**PROPOSED PLAYGROUND  
PROJECT AT  
THE GLEN, ASCAL A TRÍ,  
DROGHEDA, CO. LOUTH**

*LOUTH COUNTY COUNCIL*

**QUALITY AUDIT  
AND  
ROAD SAFETY AUDIT**

**PROPOSED PLAYGROUND PROJECT AT  
THE GLEN, ASCAL A TRÍ, DROGHEDA, CO. LOUTH  
QUALITY AUDIT AND ROAD SAFETY AUDIT**

## 5.1 Conflict with Existing Driveway

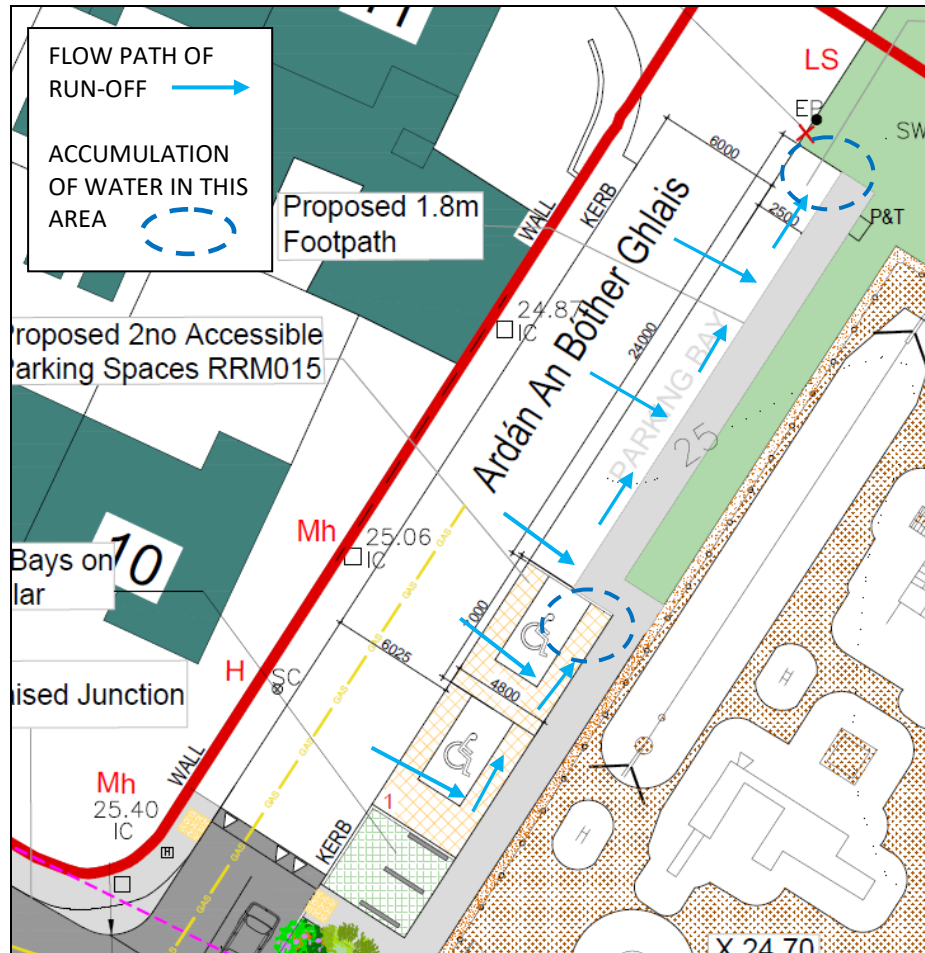
The west arm of the raised table extends to the boundary between No.9 and No.10 Ascal a Trí. This creates a conflict with the existing driveway to No.10. In particular the proposed pedestrian crossing point is directly in line with the driveway entrance.

The current layout creates a conflict between vehicles entering/exiting the driveway and pedestrians using this crossing

Reduce length of the west leg of the raised table to avoid conflict with the driveway

<b>Item Ref.</b>	<b>Identified Problem</b>	<b>Designers Response</b>
5.1	Conflict with Existing Driveway	Length of west arm of raised table reduced Refer to Drg. No. LCC-GLEN-DRG -3.1 (16/03/26)
5.2	Drainage of Car Park Areas	Additional Road Gullies provided Refer to Drg. No. LCC-GLEN-DRG -3.1 (16/03/26)
5.3	Bicycle Parking	Bicycle stands now centrally located Refer to Drg. No. LCC-GLEN-DRG -3.1 (16/03/26)
5.4	Level Difference along West Boundary of Play Ground	Option 2 Applied Refer to Drg. No. LCC-GLEN-DRG -3.1 (16/03/26)

## 5.2 Drainage of Car Park Areas

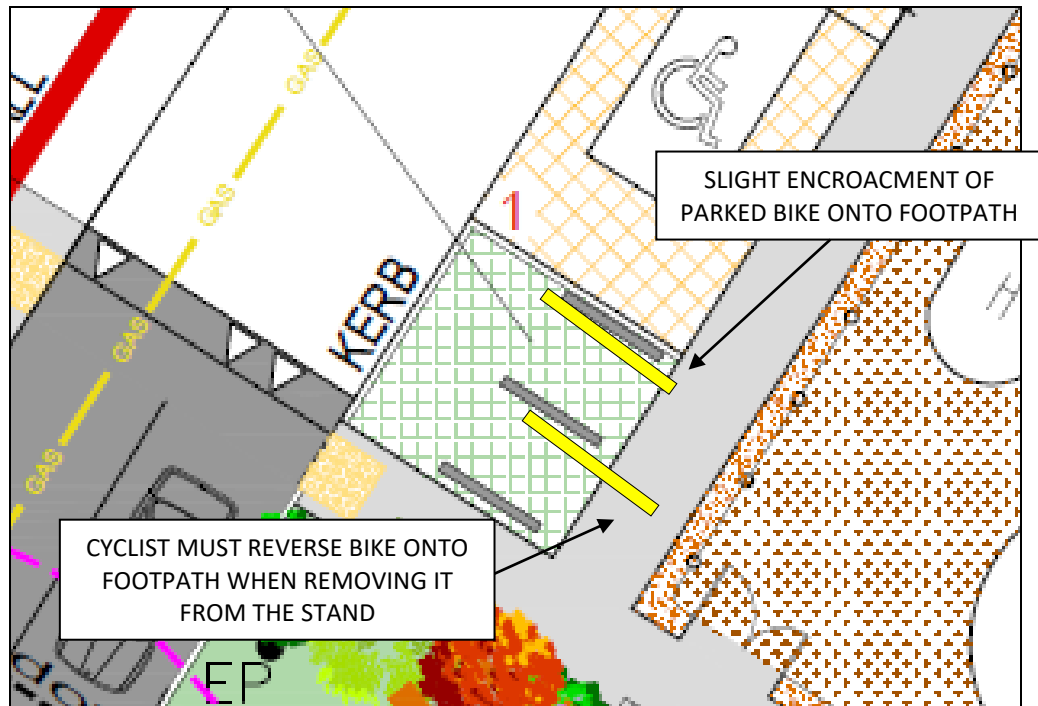
No provision has been made to cater for surface water run-off from the proposed car park areas.

The road gradient means that run-off from these car park areas and part of the adjoining road shall accumulate in the north-east corner of each car park area. The absence of a road gully at these locations shall result in ponding of water within these areas with resultant inconvenience and hazard to drivers and pedestrians.

Provide road gully in the north-east corner of each car park area and link into existing SW network.

## 5.4 Treatment of Level Difference Along West Boundary of the Playground

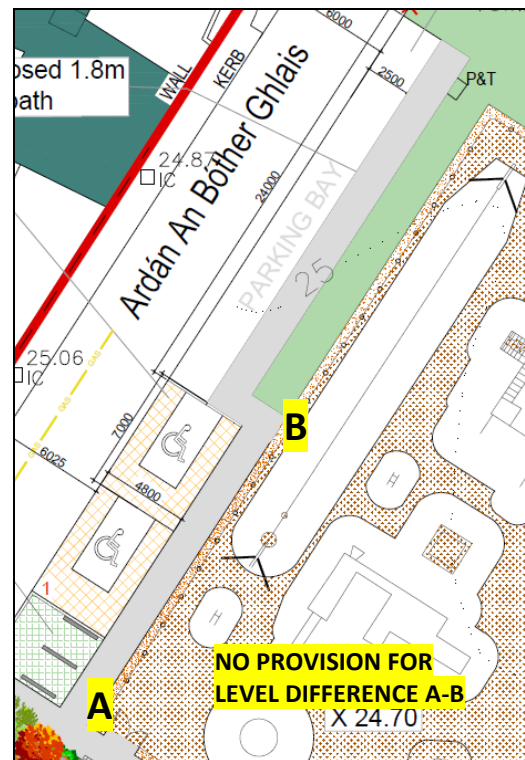
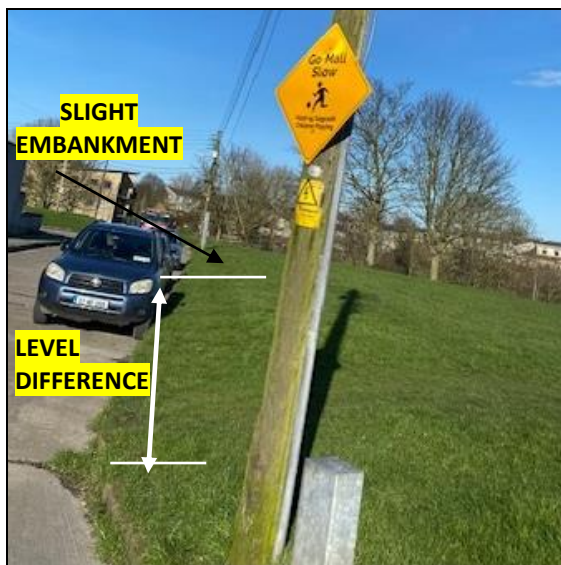
The site of the proposed playground is slightly elevated relative to existing road levels along Ardán An Bother Ghlais.

This level difference is currently catered for by a slight sloped embankment running along the west boundary of the open space area.

The provision of the proposed car parking spaces and adjoining footpath along Ardán An Bother Ghlais shall cause the removal of this embankment.

The level difference can be accommodated within the grass strip being provided between the footpath and playground along the standard car park spaces. However, no such buffer is provided between the playground and the footpath running along the rear of the less able car parking spaces.

Option 1 – Provide low retaining wall to rear of footpath

Option 2 – Move Playground slightly towards the east to create a sloped grass embankment as a buffer zone between the footpath and playground
